Rail Tie Wind Project Final Environmental Impact Statement

DOE/EIS-0543
November 2021

RAIL TIE WIND PROJECT FINAL ENVIRONMENTAL IMPACT STATEMENT

Lead Agency: Western Area Power Administration

Figure 1. "Modeled Received Sound Levels" (Report Figure 2).

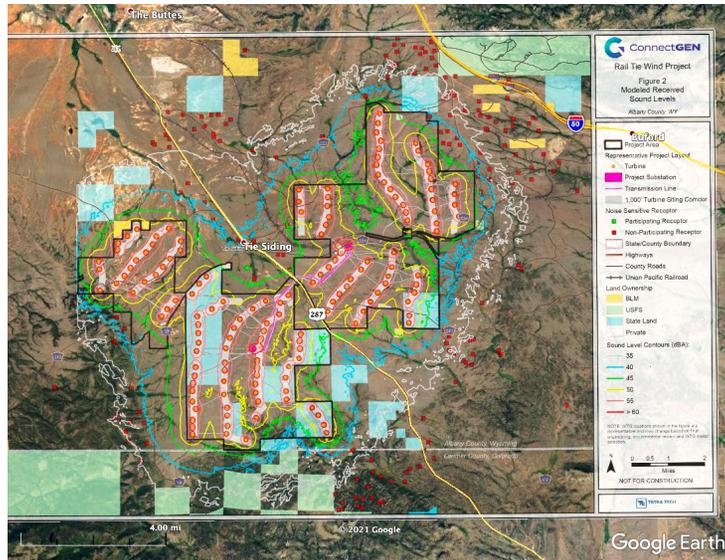
10. Whereas, the Report uses the Leq average sound level for its sound modeling, ignores known noise fluctuations, and concludes that the Project will not exceed 55 dBA at all project property lines. See this review's Figure 1 below, which provides the Report's predicted average sound levels.

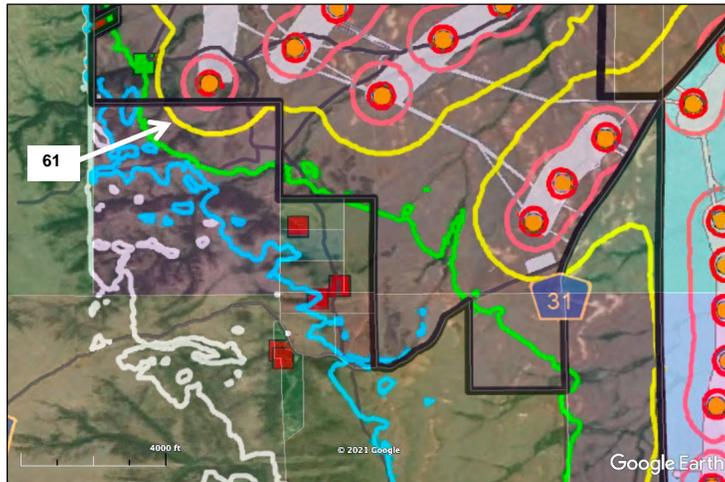
11. This review's Figure 2 below provides the Report's predicted average sound levels closer up, at the southern project property lines. Conservative adjustments of +11 dB are noted based on documented wind turbine fluctuations discussed earlier. Fluctuations include amplitude modulation occurring at the blade pass rate and coincident addition of multiple turbines' modulating noise emissions. The conservative adjustments show the highest fluctuating sound levels associated to the Report's predicted contour levels.

- The Report omitted manufacturer's highest fluctuating noise data acquired via IEC 61400-11 Annex A. Comprehensive IEC 61400-11 noise tests would necessarily include acquiring non-averaged, fluctuating amplitude modulation noise levels under various wind conditions. Maximum noise levels determined from IEC 61400-11 Annex A.5 are undoubtedly available from Vestas, who most certainly has exercised its due diligence and measured every permutation of sound output and amplitude modulation ranges including highest fluctuating or Lmax noise maximum levels for its turbine models, under a wide variety of atmospheric conditions including shear and low level jetting.

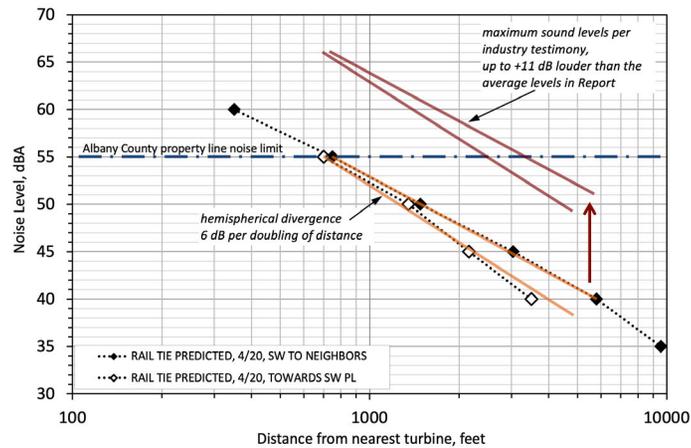
15. To review fluctuating level impacts, Report Figure 2 was imported into Google Earth Pro and scaled at the project location with a tolerance of +/- 50 feet. Project-predicted sound level versus distance was assessed by measuring distance to contours for two locations; 1) a turbine set apart from others, where hemispherical divergence could be obtained (6 dB per doubling of distance, the expected drop with distance for a sound source), and 2) sound levels with distance for a line of turbines, where the drop with distance is generally in the range of 3 to 6 dB per doubling. The results are shown in Figure 3 below.

17. As seen in Figure 3, once industry measured fluctuating decibel ratios are factored in: depending on turbine proximity to other turbines, a setback from property line of roughly 1/2 to 2/3 mile feet is needed to comply with County property line noise limits.

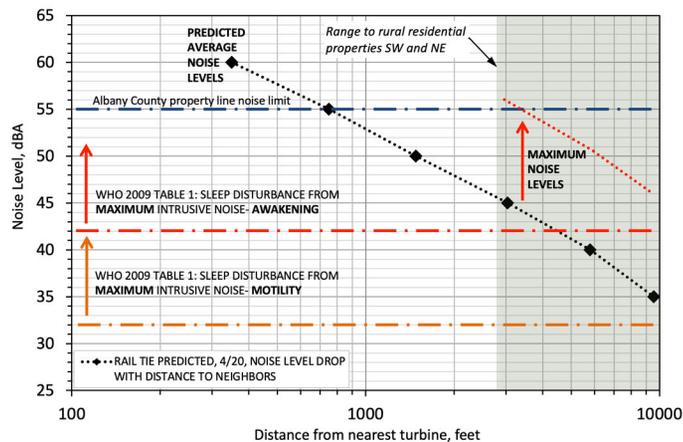
24. Probable maximum noise levels in Figure 6 should be compared to the indicated WHO indoors sleep health thresholds 32 and 42 dBA L_{max,inside} by subtracting 1-3 dBA from maximum outdoors noise levels (Vermont testing by two independent firms of large wind turbine outdoor to indoor noise reduction, 2014 [11]).

Figure 7. Noise predictions show facility intrusive noise levels would breach ANSI S12.9 guidelines for compatibility with rural residential land use at night at nearest residential properties southwest and northeast of the proposed facility.

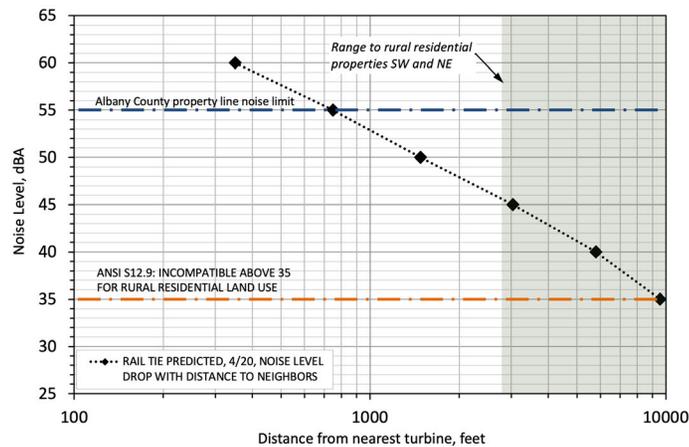
25. The American National Standards Institute (ANSI) provides land use compatibility guidelines in S12.9 Parts 4 & 5. In short, long term average unfamiliar, intrusive sound levels under 30 dBA are compatible and levels over 35 dBA are incompatible with quiet rural residential land use at night (amenity). See this letter's Figure 7. Predicted facility noise levels are certain to breach ANSI threshold for incompatibility with quiet rural residential land use out to some two miles.

26. ANSI land use compatibility speaks directly to impacts on rural serenity and amenity. When ANSI compatibility guidelines are observed for quiet rural land use, serenity and amenity is preserved. Whereas, the facility as currently designed predicts degradation of the nighttime rural amenity.
